**APPROVED MINUTES OF THE REGULAR SESSION OF THE
BUILDING BOARD OF APPEALS OF THE CITY OF ANN ARBOR
JUNE 13, 2007- 1:30 P.M. – SECOND FLOOR – CITY COUNCIL CHAMBERS
100 N. FIFTH AVENUE, ANN ARBOR, MI 48104**

C-1 2007-B- 010 – 1210 Cambridge Court

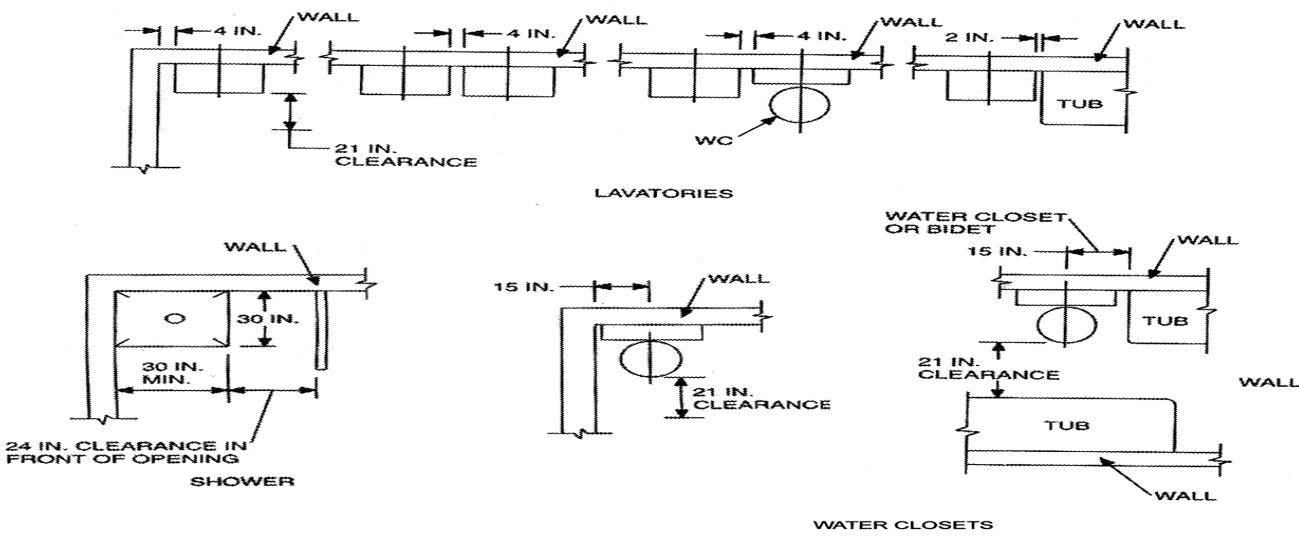
The applicant is requesting a variance from Section R307.1 of the 2003 Michigan Residential Code that requires that toilet fixtures spaced per the following diagram.

This property is rental housing. During the most recent housing inspection, it was found that the second floor bathroom does not meet code with relation to fixture clearances. The toilet has only 6 inches in front of it to the tub/shower wall. Code requires a minimum clearance of 21 inches in front of the toilet. There is no permit on file for this work, and consequentially no inspection or final approval.

A. Savoni - Staff is not supportive of this request. This layout clearly does not meet code for minimum clearances and provides a hazard for anyone using the bathroom. It must be corrected to meet code. We couldn't locate any building permits for this work, so we don't know if it was existing, and we're not sure how it got this far without a Housing Inspector finding it.

83 S. Callan – The dimensions are 6 inches of clearance between the toilet and shower and the
84 required clearance is actually 21 inches? (A. Savoni – Yes. It would be hard to believe that
85 they would have allowed this under any code from years ago.)
86

89 K. Winters – In your additional letter, you state that this is a dormer? (Petitioner – Yes. It has a
90 dormer with a gable roof so we can't go to either side to move anything without building a bigger
91 dormer.) There is no bedroom next to it? (Petitioner – There is a bedroom there but because of
92 the way the roof is, there is no headroom.) One solution would be to enlarge the dormer.
93 (Petitioner – Yes, but I don't know that that will be any less expensive than moving the
94 plumbing.)
95

96 S. Callan – Is there anything such as a 'narrow profile' toilet? (Petitioner – The smallest toilet is
97 26 inches front to back.) That might improve the clearance a bit,
98

99 P. Darling – I think the best opportunity would be to modify the tub. The plumbing for the toilet is
100 always has the biggest trap. (Petitioner – But the drain is the problem. You'd have to put the
101 drain at the other end to shorten it.)
102

113 R. Hart – (Suggested that the door swing out to provide more room.) The small bump out next
114 to the toilet – what is that? (Petitioner – I believe it is the vent). If the toilet was rotated around
115 so that it faced the long way, the lav could be shifted toward the door, and the door swung out –
116 whether that might get what they're looking for.
117

118 K. Winters – So, there are options here. (Petitioner – There are options, just expensive
119 options). Having only 6 inches of clearance in there is not going to make it.
120

127 K. Winters – At this point, it's not up to the Board to design this, and we're not going to approve
128 a variance as it is, so you'll have to come back here and either meet the code by some of the
129 suggestions we've given you here, or come back with an improvement on this that would still
130 require a variance. (Petitioner – I need clarification on the 30-inch minimum – for the shower.
131 Can I put a 27 by 48 inch tub in there?) There's no minimum for a tub, so you could put a 27 by
132 48 inch tub/shower in there, as long as you have the clearances.
133

139 Moved by S. Callan, Seconded by R. Hart, "to table Appeal Number 2007-B-010, 1210
140 Cambridge Court for 60 days. The issue shall be returned to the table for closure no later
141 than the August Regular Session."

145 **C-2 2007-B-011 – 307 Mulholland Avenue**

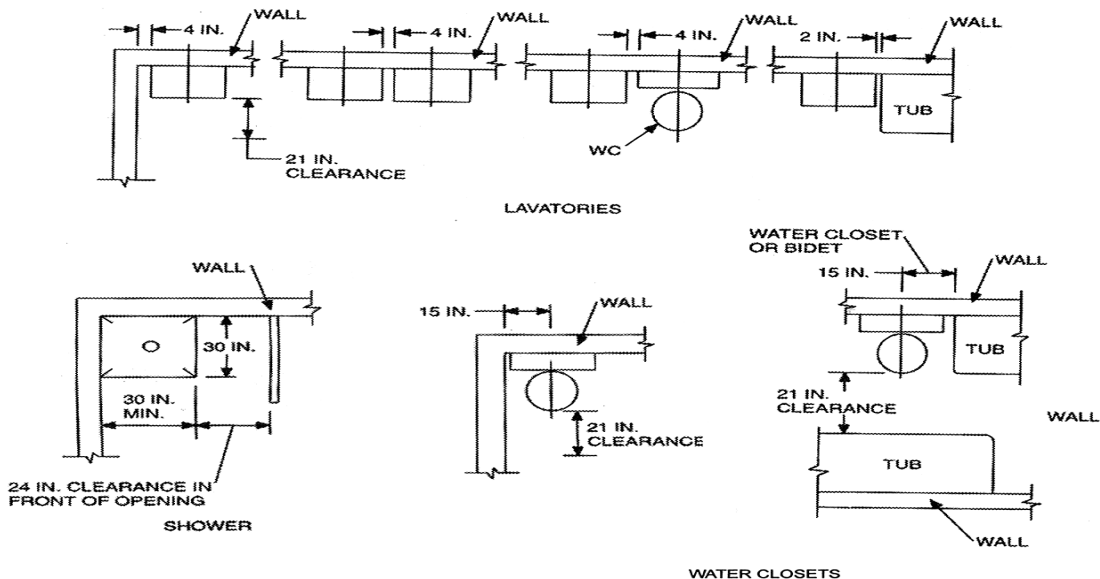
150 The applicant is requesting a variance from Section R307.1 of the 2003 Michigan
151 Residential Code that requires that toilet fixtures spaced per the following diagram.

169 Petitioner is proposing to remodel the second floor bathroom. The proposed remodeling plan
170 does not meet code. Petitioner is proposing a plan that will have 10 inches of clear space in
171 front of the toilet and 17 inches of clear space in front of the lavatory. Code requires 21 inches
172 of clear space at both locations. Applicant is applying for a variance prior to starting this work.

193 A. Savoni - Staff is not supportive of this request. This layout clearly does not meet code for
194 minimum clearances and provides a hazard for anyone using the bathroom. It must be
195 corrected to meet code.

201 P. Darling – You show layouts – one with a sink and a base cabinet and one with a pedestal
202 sink. Are you suggesting using the one with the base cabinet? (Petitioner – Yes, primarily
203 because storage is so limited in this house.) I think there are benefits with the pedestal sink.

205 K. Winters – Is this a rental unit? (Petitioner – Yes, it is.) Again, similar to the case just
206 previous, there is always the possibility of going to the 30 in. x 30 in. or 30 in. x 36 in. shower
207 here, and still providing you the chance to put in the linen closet – moving the access door over
208 and into the bathroom in order to give you some space. (Petitioner – I don't think we would
209 consider that. I've asked a number of tenants if they would consider a house that did not have a
210 tub, and their answer is "no.")

212 P. Darling – There was probably a sink in there originally that was wall hung, so maybe they
213 were using that space under the sink for additional legroom. (Petitioner – For practical
214 consideration, I've rotated that toilet 15 degrees and you have about 3 ft. in front of you when
215 you stand up." (Petitioner – States that he can get an Alger pedestal sink that is 21-½ in. wide
216 along the wall and 16-¾ in. deep. Some room will be created to alter the room as the Historic
217 District Commission has granted permission to move the existing window.)

221 Moved by P. Darling, Seconded by S. Callan, **“to grant a variance for Appeal Number**
222 **2007-B-011, 307 Mulholland Avenue, to allow the relocation of a 30 inch by 60 inch**
223 **tub and the installation of a pedestal sink that provides a minimum clearance of**
224 **13 inch from the lip of the toilet to the edge of the sink. We find that this is an**
225 **improvement over the existing condition in as much as that space will permit. The**
226 **dimension from the edge of the tub to the lip of the sink shall not be less than**
227 **19 inches.”** On a Voice Vote – MOTION PASSED – **UNANIMOUS**
